## **Access Compliance Report Public Rights-of-Way** (Curb Ramps)

Intersection ID: 13420 Main Street: S TRYON ST Cross Street: W BLAND ST Location: N

ADA ID: 7CC4E7A9A072 Ramp Type: BlendTrans2 Initial Pass/Fail: Fail **Overall Compliance: No Severity Score:** 8.75

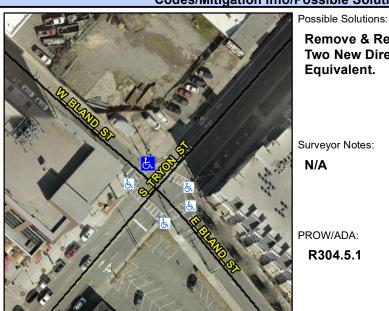
Compliance Description D		Data	Comp	liance Description	Data
N/A	Ramp Length (in)	51.0	Yes	BlendTrans Slope (%)	3.6
No	Ramp Width (in)	40.0	Yes	BlendTrans XSlope (%)	0.6
N/A	Flare Type LT	N/A	N/A	Flare Type RT	N/A
N/A	Flare Slope LT (%)	N/A	N/A	Flare Slope RT (%)	N/A
N/A	Flare Traversable LT?	N/A	N/A	Flare Traversable RT?	N/A
N/A	Landing Length (in)	N/A	N/A	DWS Provided?	N/A
N/A	Landing Width (in)	N/A	N/A	DWS Contrast?	N/A
N/A	Landing Slope (%)	N/A	N/A	DWS Length (in)	N/A
N/A	Landing X Slope (%)	N/A	N/A	DWS Full Width?	N/A
N/A	Landing Curb? (Y/N)	N/A	N/A	DWS Offset (in)	N/A
N/A	Shared Landing?	N/A			
N/A	Gutter Ponding?	N/A	N/A	Gutter Slope (%)	N/A
N/A	Gutter Lip Ht (in)	N/A	N/A	Gutter X Slope (%)	N/A
N/A	Painted X Walk1?	Yes	N/A	Painted X Walk2?	Yes
	X Walk 1 Direction	To SW		X Walk 2 Direction	To SE
	X Walk 1 Width (in)	96.0		X Walk 2 Width (in)	107.0
	X Walk 1 Slope (%)	5.0		X Walk 2 Slope (%)	3.7
	X Walk 1 X Slope (%)	1.3		X Walk 2 X Slope (%)	1.3

N/A	Ramp inside XWalk1?	Yes	N/A	Ramp inside XWalk2?	Yes
	Road Slope (%)	1.4		Clear Space?	N/A
	Road X Slope (%)	8.8	N/A	Clear Space to XWalk (in)	N/A
N/A	Any Obstructions?	N/A	N/A	Storm Grate/Utility Hazard?	N/A
	Obstruction Type			Storm Grate/Utility Type	
		N/A			N/A
			١.,	0 ( 0 ) ( 0 ) ( 5 (-)

Remove & Replace Curb Ramp With **Two New Directional Ramps or** Equivalent.

R304.5.1
